**16/04482/LBC (CT.0507/1/M)**

**Mill House  
Cotswold Mill  
Lewis Lane  
Cirencester  
Gloucestershire  
GL7 1EL**

**Loft conversion to include staircase, landing, bathroom and bedroom. Installation of 4 No. conservation roof windows in North West elevation and reinstatement of original second floor window to the North East elevation at Mill House Cotswold Mill Lewis Lane Cirencester Gloucestershire**

<b>Listed Building Consent 16/04482/LBC (CT.0507/1/M)</b>	
<b>Applicant:</b>	Mr Tilbury
<b>Agent:</b>	Cotswold Extension & Conversion Design
<b>Case Officer:</b>	Lydia Lewis
<b>Ward Member(s):</b>	Councillor Joe Harris
<b>Committee Date:</b>	8th February 2017
<b>RECOMMENDATION:</b>	<b>REFUSE</b>

Cross Section Elevation

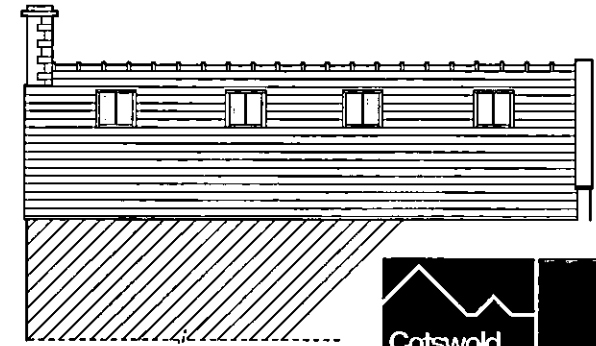
The building appears to have been reroofed at some point with modern rafters and roofing felt, however on inspection and in the absence of any historic analysis being provided with the application, the primary roof structure appears to be of some significant age and constitutes important historic fabric. The special interest of the building includes this historic primary roof structure.

The original proposals included the removal of three timber roof trusses. The Council consider that the timber trusses are an integral part of the historic primary roof structure and their removal would result in the loss of valuable historic fabric and the historic structural form of the roof and compromise the historic integrity of the listed building. Amended plans have been received that propose the careful removal and retention of one diagonal strut from each king post. The Conservation Officer has considered the revised proposals and has advised that the proposal still involves removing a key element of the primary roof structure of the listed building and for the reasons outlined above they still would not be able to support the proposals.

The applicants' agent states within the submitted Design and Heritage Statement that they consider no harm would be caused to the fabric of the building as the king pin trusses are an entirely hidden component, not visible, and designed purely for structural purposes.

The fact that the roof structure to be removed could not be seen does not prevent it from compromising the historic integrity of the building. This has been supported by Planning Inspectors at appeal. For example, an application at Whalley Farm, Whittington to alter an existing collar of a roof truss was dismissed in April 2009 (Appeal reference: APP/F1610/E/09/2107145). The Inspector considered that 'the special interest of this building includes the various roof trusses and collars...all of these features contribute to the historic pattern of the roof structure and are an important part of the history and evolution of the building.' '...the works would entail the loss of important historic fabric within this listed building and would erode the historic pattern of the roof structure...the scheme would unacceptably harm the historic integrity of the roof truss and the internal character and special interest of this grade II listed building.' 'It is not uncommon in attic storeys of historic buildings for timbers to impede access and for such areas to be only suitable for storage.'

Hidden Roof Elevation North West

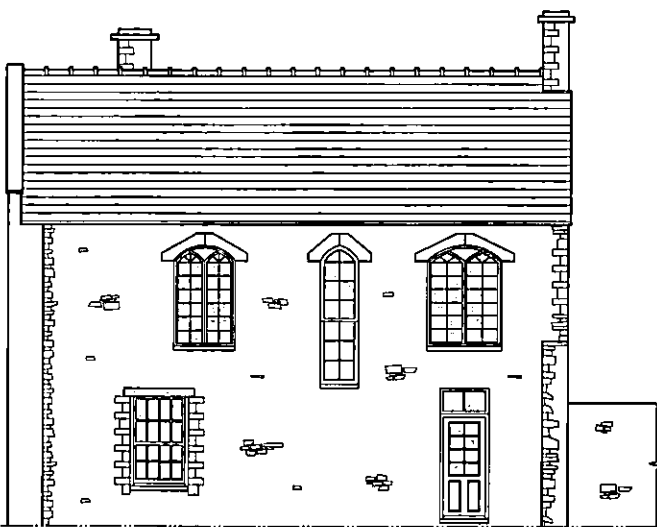
The original proposal included 3 roof lights in the south east roof slope. In response to concerns raised from the Conservation Officer, these were removed and 4 rooflights are now proposed in the north west roof slope. Although 4 rooflights seems a little excessive, given their location on an internal roof slope, on balance no objection is raised.

Proposed Elevation North East

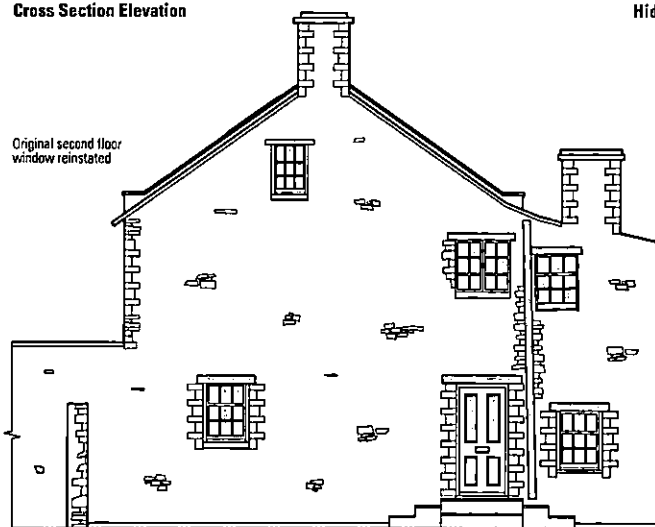
The application proposes the reinstatement of an original second floor window to the north east elevation. No objection is raised to this element of the proposal, subject to detailed design.
